**SUBJECT: PROPOSED MODIFICATIONS TO SILVER WOODS SUBDIVISION
AND ANNEXATION INTO THE TOWN OF OCEAN VIEW
PLUS 2011-02-01
SUSSEX COUNTY DELAWARE**

This letter has been prepared to respond to comments issued by the Office of State Planning Coordination dated March 21, 2011 stemming from a review pursuant to State regulations and Preliminary Land Use Service (PLUS) requirements regarding the aforementioned application. Accordingly, the proposed project consists of an application for annexation into the Town of Ocean View from Sussex County. As part of the annexation process, a rezoning would occur from the existing zoning of General Residential (GR) in Sussex County to a Mixed-Use Residential Community (MCPC) zoning within the Town of Ocean View.

Figure A
Recharge and Wellhead Protection Area Data
Source: Delaware Environmental Navigator

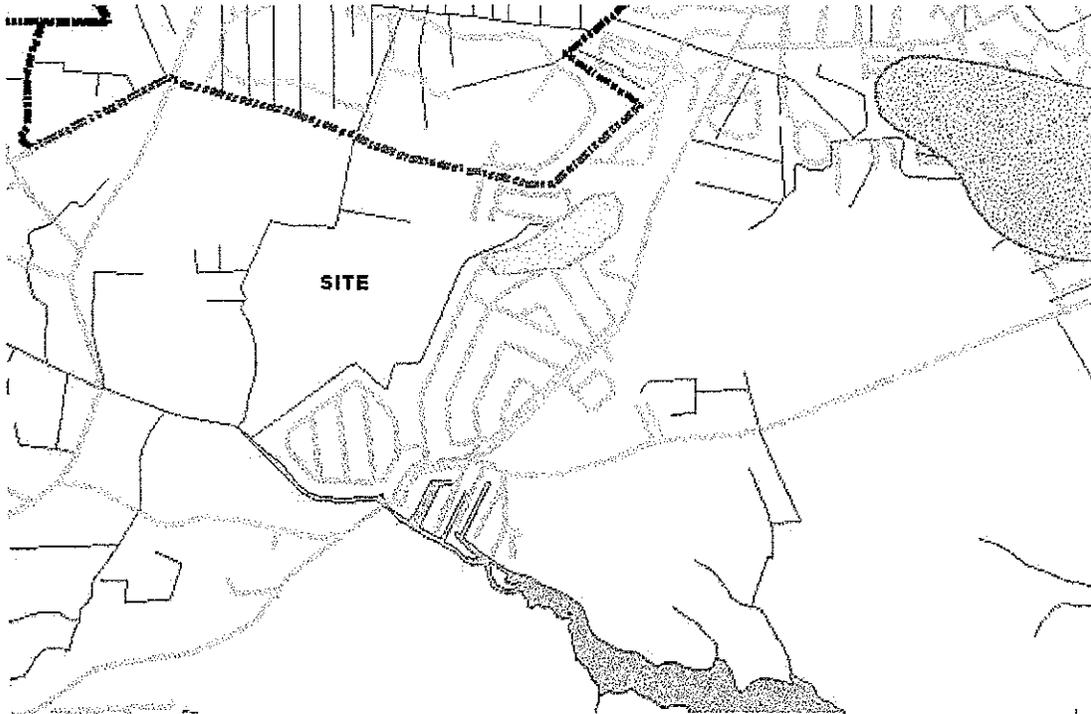
COMMENT: (NOTE: Figure referenced has not been reproduced for brevity)
A large portion of the Phase 2 project proposed in this application is likely to fall within wellhead protection for Tidewater Utilities Bethany Bay/Ocean View District (see map).

RESPONSE: The Developer appreciates the need to protect designated wellhead areas. However, according to online mapping through DNREC's Environmental Navigator available at: <http://maps.dnrec.delaware.gov/navmap/> no designated wellhead area is shown within any reasonable proximity to the proposed project site. In addition, the designated recharge area referenced is shown in close proximity to the existing Phase I. A representation of the DNREC Environmental Navigator data for the site is shown below as Figure A:

Therefore, the only reasonable conclusion that can be drawn from the statements included in comments from the OSPC is that the declaration of a potential WHPA is actually **pre-Phase I**, as the applicant has not received the official notice described as a requirement of the State of Delaware Wellhead Protection Program and, correspondingly not in-force.
